**1 Products affected**

**3 Detailed description of change**

Product Change Notification					PCN EC11-New Connections		
owner	creation date	release date	released by	change order	rev	page	D10-067-746
huberth	02.09.2022	12.09.2022	muehlema	2024666	A	1 of 2

Current product appearance	New product appearance

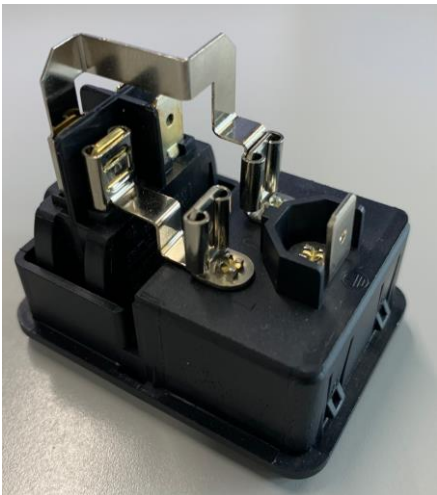
- Wire connection between inlet and switch replaced by brass brackets

| <ul style="list-style-type: none"> <li><input checked="" type="checkbox"/> Form</li> <li><input type="checkbox"/> Fit</li> <li><input type="checkbox"/> Function</li> <li><input type="checkbox"/> Manufacturing</li> <li><input type="checkbox"/> Label</li> <li><input type="checkbox"/> Packaging</li> </ul> | <p>Verify installation dimension and check insulation requirements.<br/>If required use rear cover RC 320-07 (Article 3-125-667).</p> |
